Figure 7B-1. Signs in School Areas and at School Crossings (Sheet 1 of 2)

Summary of Comments on CAMUTCD 2026 7B Fig.pdf

Summary of Comments on Part 7B Figure CA MUTCD 2026

Figure 7B-2. Example of Signing for a School Zone with a School Speed Limit and a School Crossing

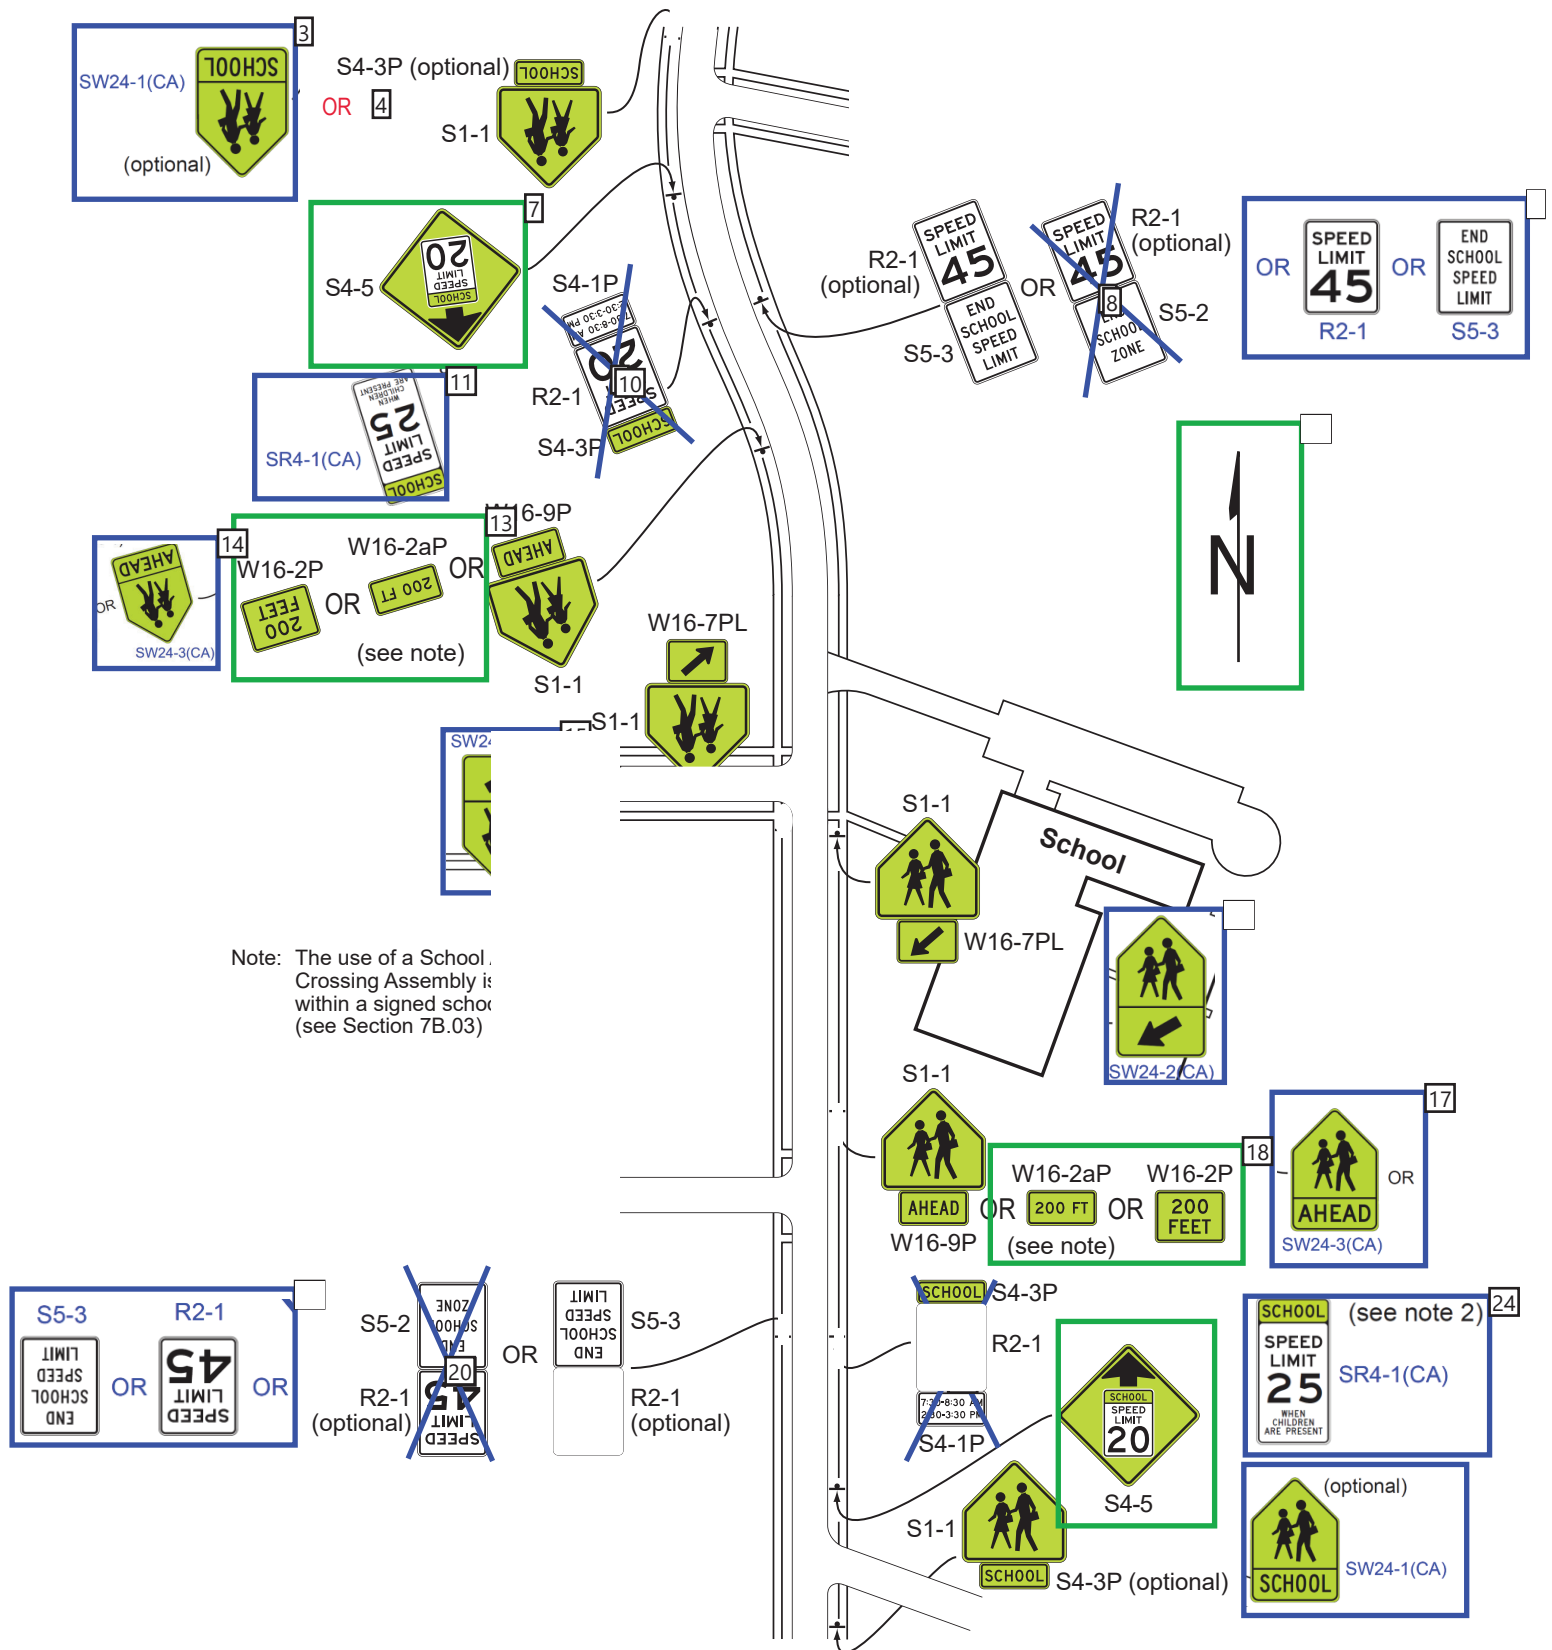
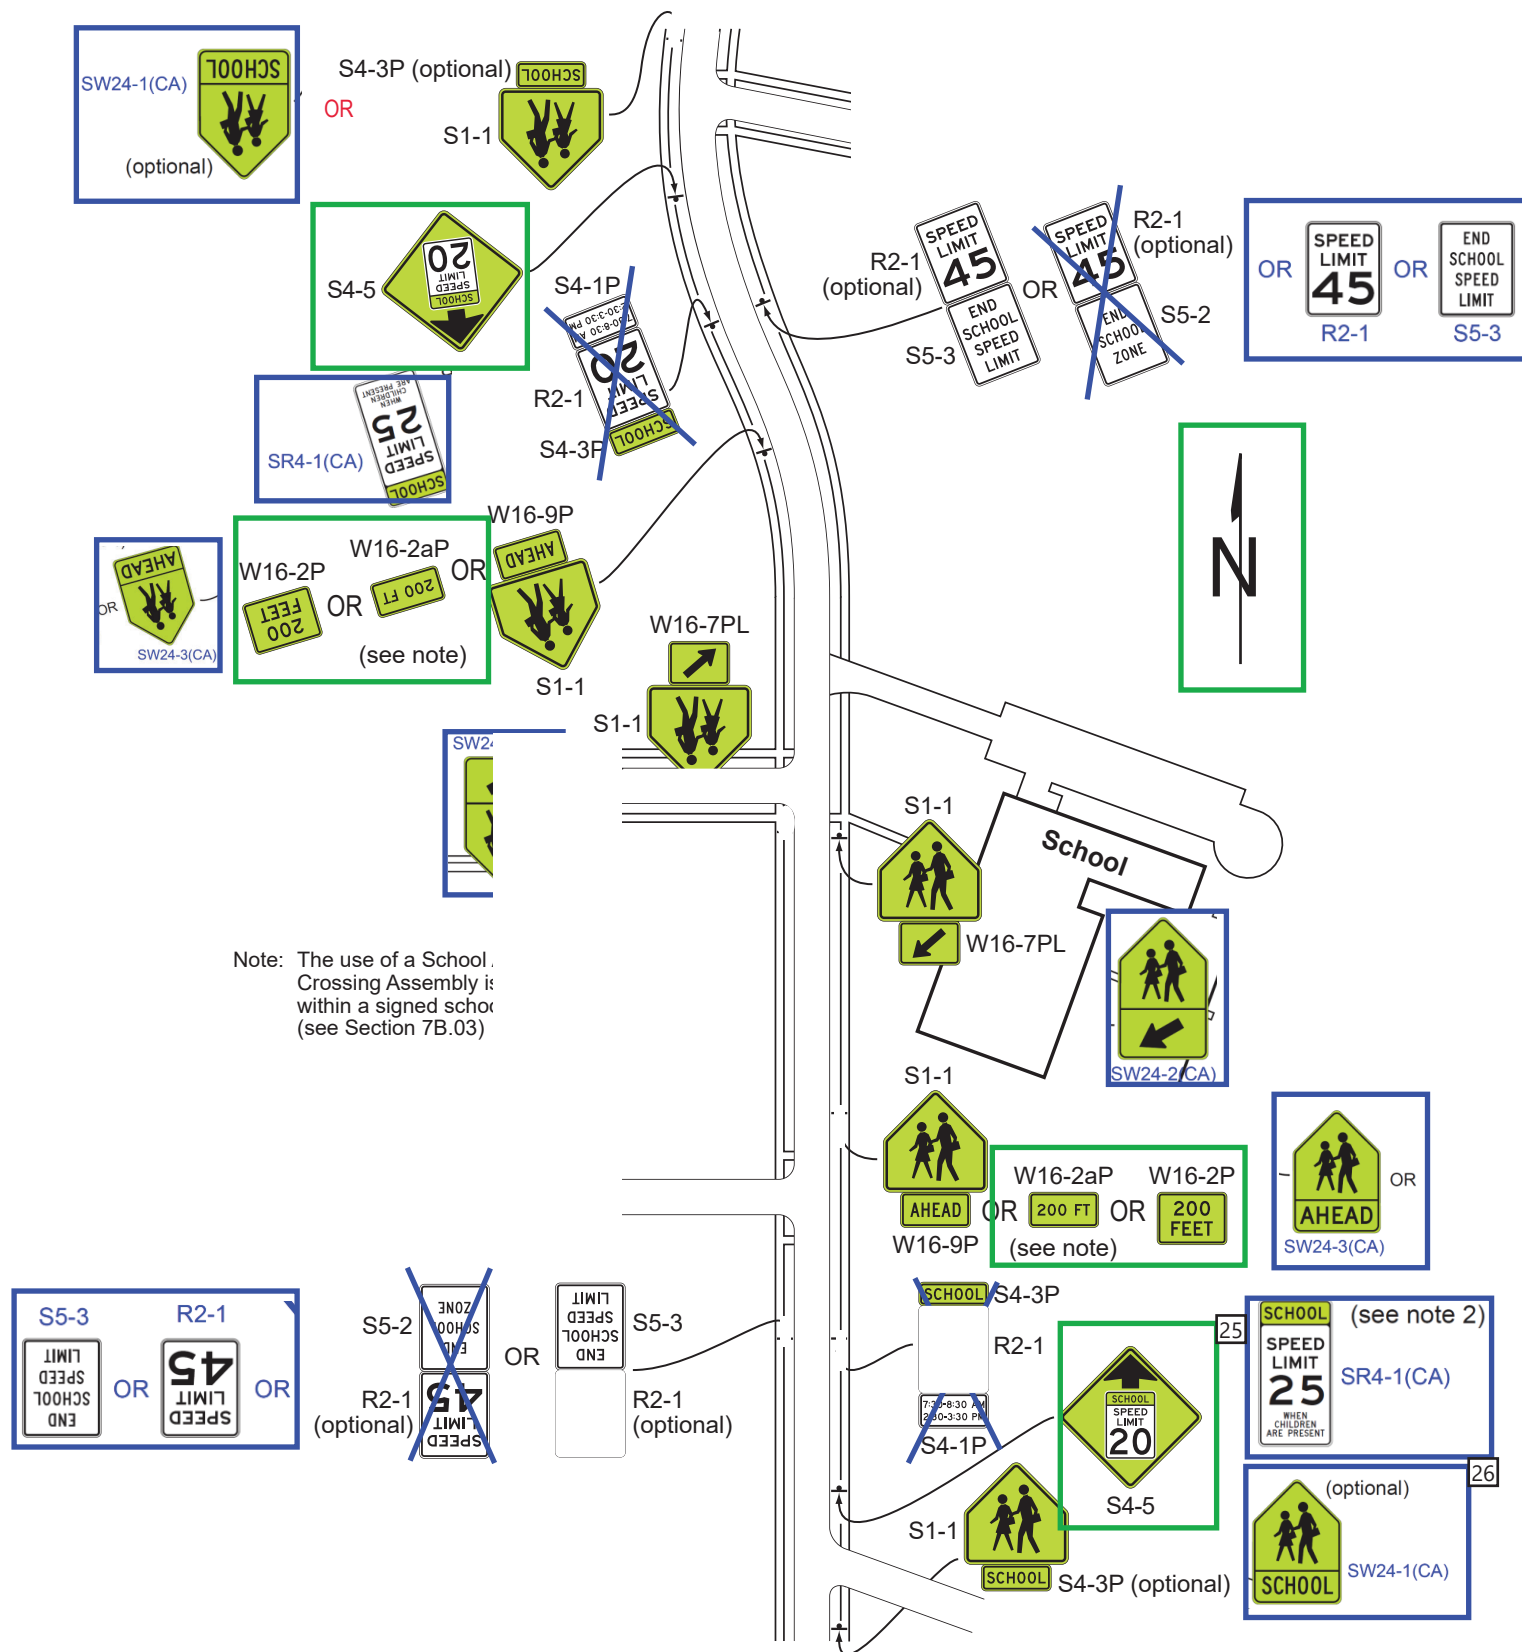
Number: 1	Author: s116730	Subject: Highlight	Date: 7/25/2024 9:48:20 AM
NMUTCD 2023 added sign codes for all signs, which were missing in NMUTCD 2009 figures				
	Number: 2	Author: s116730	Subject: Highlight	Date: 7/25/2024 9:48:24 AM
NMUTCD 2023 changed NMUTCD 2009 Figure 7B-5 to 7B-2 and added sign codes for the signs shown in the figure.				
	Number: 3	Author: s116730	Subject: Rectangle	Date: 7/10/2024 9:45:30 AM
Incorporated from CA MUTCD 2014R8 Figure 7B-5				
	Number: 4	Author: s116730	Subject: Text Box	Date: 7/10/2024 9:43:42 AM
OR				
	Number: 5	Author: s116730	Subject: Line	Date: 7/10/2024 9:37:58 AM
	Number: 6	Author: s116730	Subject: Rectangle	Date: 7/10/2024 9:55:06 AM
Incorporated from CA MUTCD 2014R8 Figure 7B-5				
	Number: 7	Author: s116730	Subject: Rectangle	Date: 7/14/2024 8:38:40 AM
NMUTCD 2023 added new sign				
	Number: 8	Author: s116730	Subject: Line	Date: 7/10/2024 9:37:47 AM
	Number: 9	Author: s116730	Subject: Line	Date: 7/10/2024 9:38:20 AM

Number: 10	Author: s116730	Subject: Line	Date: 7/10/2024 9:38:20 AM
	Number: 11	Author: s116730	Subject: Rectangle	Date: 7/10/2024 9:55:55 AM
Incorporated from CA MUTCD 2014R8 Figure 7B-5				
	Number: 12	Author: s116730	Subject: Rectangle	Date: 7/14/2024 8:40:44 AM
NMUTCD 2023 added new cardinal direction "N" arrow				
	Number: 13	Author: s116730	Subject: Rectangle	Date: 7/13/2024 10:10:07 AM
NMUTCD 2023 added new plaques				
	Number: 14	Author: s116730	Subject: Rectangle	Date: 7/10/2024 2:53:25 PM
Incorporated from CA MUTCD 2014R8 Figure 7B-5				
	Number: 15	Author: s116730	Subject: Rectangle	Date: 7/10/2024 2:34:53 PM
Incorporated from CA MUTCD 2014R8 Figure 7B-5				
	Number: 16	Author: s116730	Subject: Rectangle	Date: 7/10/2024 2:35:20 PM
Incorporated from CA MUTCD 2014R8 Figure 7B-5				
	Number: 17	Author: s116730	Subject: Rectangle	Date: 7/10/2024 9:56:34 AM
Incorporated from CA MUTCD 2014R8 Figure 7B-5

Number: 18	Author: s116730	Subject: Rectangle	Date: 7/13/2024 10:10:21 AM
NMUTCD 2023 added new plaques				
	Number: 19	Author: s116730	Subject: Line	Date: 7/10/2024 9:51:04 AM
	Number: 20	Author: s116730	Subject: Line	Date: 7/10/2024 9:50:49 AM
	Number: 21	Author: s116730	Subject: Line	Date: 7/10/2024 9:40:05 AM
	Number: 22	Author: s116730	Subject: Line	Date: 7/10/2024 9:39:53 AM
	Number: 23	Author: s116730	Subject: Rectangle	Date: 7/10/2024 9:56:16 AM
Incorporated from CA MUTCD 2014R8 Figure 7B-5				
	Number: 24	Author: s116730	Subject: Rectangle	Date: 7/10/2024 9:57:20 AM

☐ Number: 25 Author: s116730 Subject: Rectangle Date: 7/13/2024 10:10:35 AM
NMUTCD 2023 added new sign

☐ Number: 26 Author: s116730 Subject: Rectangle Date: 7/10/2024 9:56:45 AM
Incorporated from CA MUTCD 2014R8 Figure 7B-5

Figure 7B-2(CA) Example of Signing for a School Zone with a School Speed Limit and a School Crossing

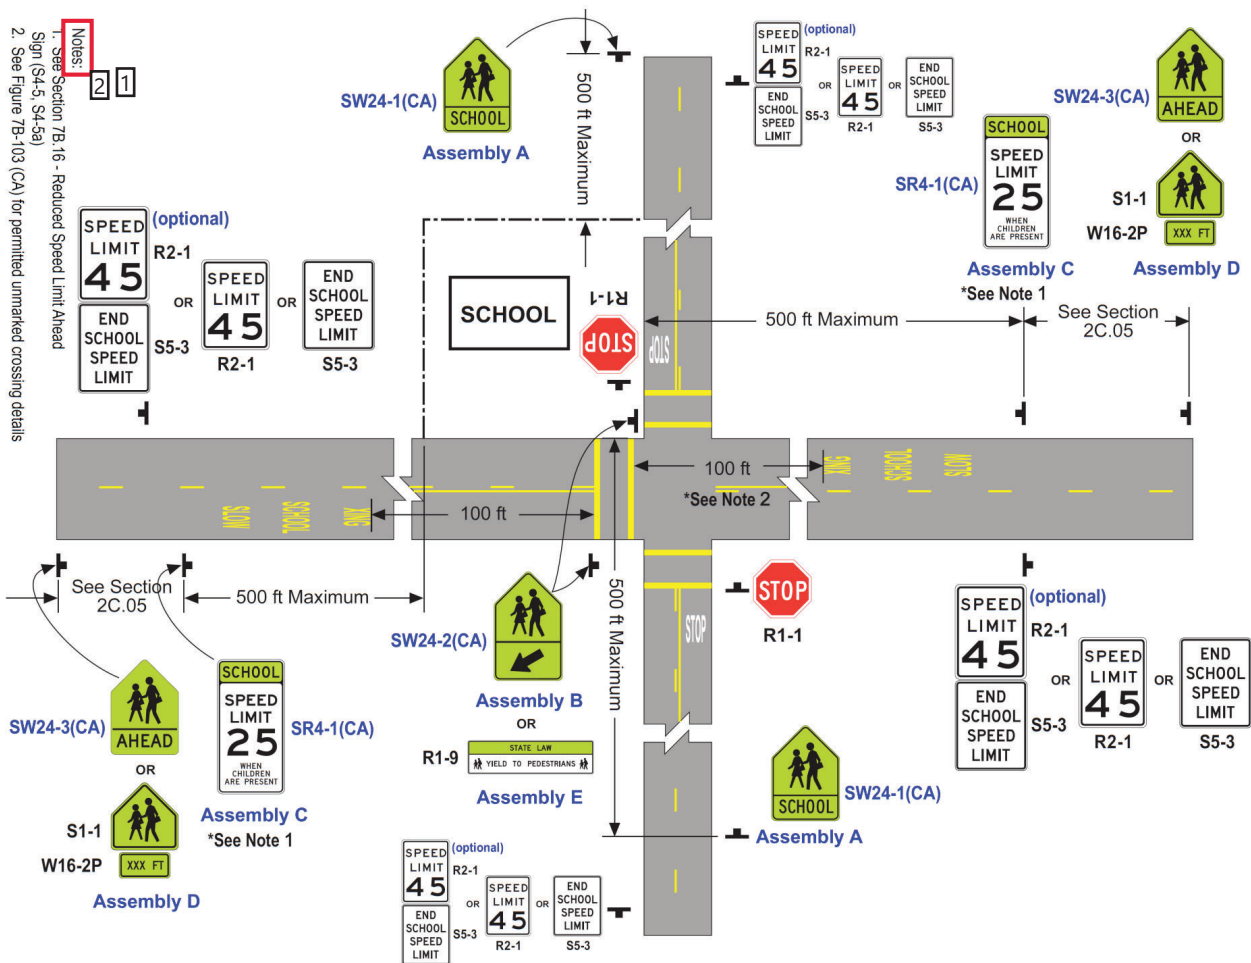
Number: 1	Author: s116730	Subject: Rectangle	Date: 7/10/2024 3:54:08 PM
	Number: 2	Author: s116730	Subject: Rectangle	Date: 7/10/2024 3:56:44 PM
	Add new note: 3. See Section 7B.02 for Assembly A(CA), Section 7B.03 for Assemblies B(CA), D(CA) and E(CA), and Section 7B.05 for Assembly C.			
	Number: 3	Author: s116730	Subject: Text Box	Date: 7/10/2024 3:39:15 PM
			7B-2(CA)	
	Number: 4	Author: s116730	Subject: Line	Date: 7/10/2024 3:52:15 PM
	NMUTCD 2023 changed NMUTCD 2009 Figure 7B-5 to 7B-2. This figure is renumbered as 7B-2(CA) and is included in CA MUTCD 2026			
	Number: 5	Author: s116730	Subject: Highlight	Date: 7/25/2024 9:49:13 AM
	NMUTCD 2023 changed NMUTCD 2009 Figure 7B-5 to 7B-2. This figure is renumbered as 7B-2(CA) and is included in CA MUTCD 2026

Figure B-3. Example of Signing for a School Crossing Outside of a School Zone

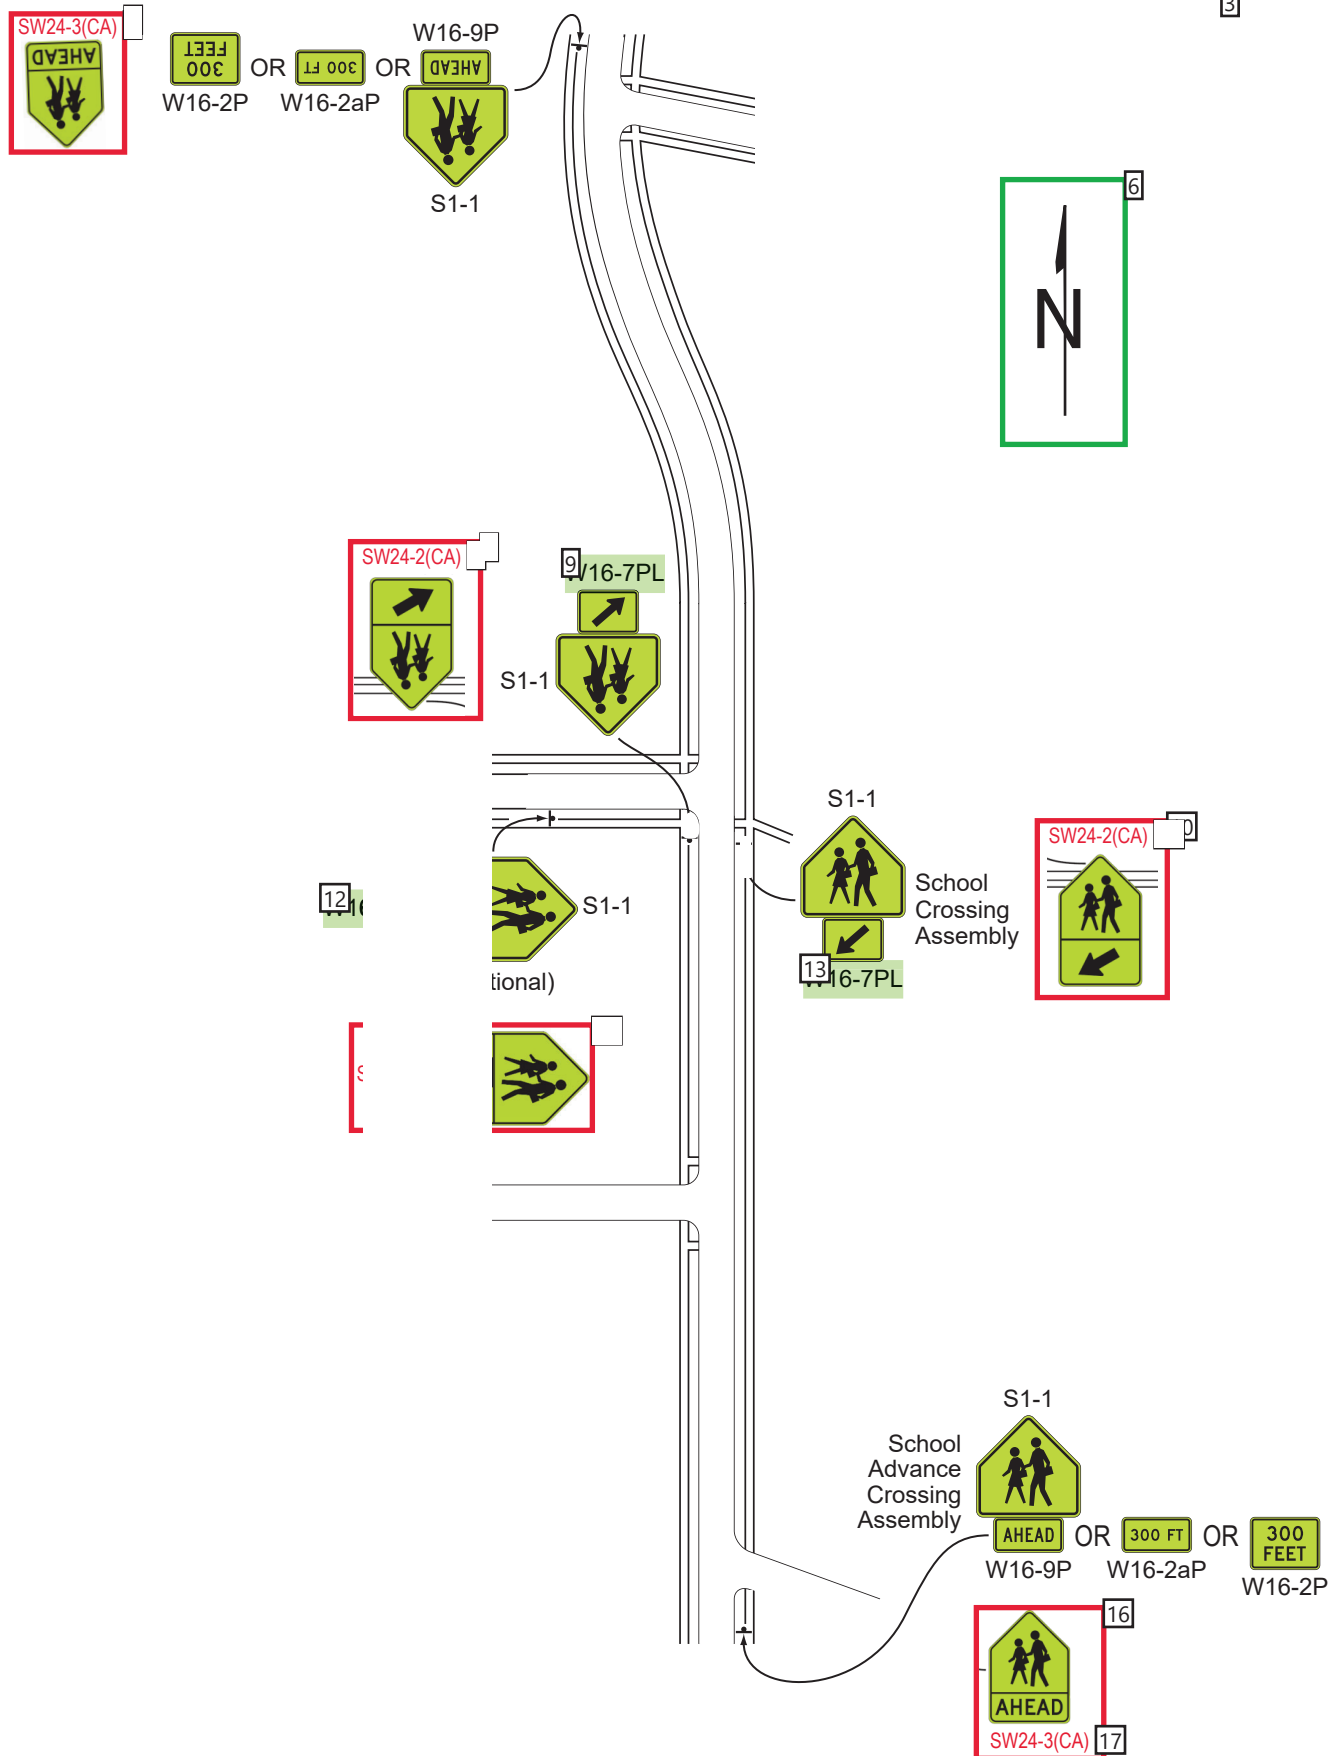
Number: 1 Author: s116730 Subject: Highlight Date: 7/25/2024 9:49:29 AM
Options for CA signs that are combined with plaques (for all signs shown on this sheet) will be added

Number: 2 Author: s116730 Subject: Highlight Date: 7/25/2024 9:49:32 AM
NMUTCD 2023 changed NMUTCD 2009 Figure 7B-4 to 7B-3 and added sign codes for the signs shown in the figure.

Number: 4 Author: s116730 Subject: Rectangle Date: 7/10/2024 3:20:12 PM
Add SW24-3(CA) Assembly D(CA) image

Number: 7 Author: s116730 Subject: Rectangle Date: 7/10/2024 3:21:59 PM
Add SW24-2(CA) Assembly B(CA) image

Number: 9 Author: s116730 Subject: Highlight Date: 7/25/2024 9:49:59 AM
NMUTCD 2023 changed the NMUTCD 2009 sign code "W16-7P" to "W16-7PL"

Number: 10 Author: s116730 Subject: Rectangle Date: 7/10/2024 3:21:47 PM
Add SW24-2(CA) Assembly B(CA) image

Number: 12 Author: s116730 Subject: Highlight Date: 7/25/2024 9:50:05 AM
NMUTCD 2023 changed the NMUTCD 2009 sign code "W16-6P" to "W16-6PR"

Number: 13 Author: s116730 Subject: Highlight Date: 7/25/2024 9:50:09 AM
NMUTCD 2023 changed the NMUTCD 2009 sign code "W16-7P" to "W16-7PL"

Number: 14 Author: s116730 Subject: Rectangle Date: 7/10/2024 3:23:06 PM
Add SW24-1(CA) Assembly A(CA) image

Number: 16 Author: s116730 Subject: Rectangle Date: 7/10/2024 3:22:25 PM
Add SW24-3(CA) Assembly D(CA) image
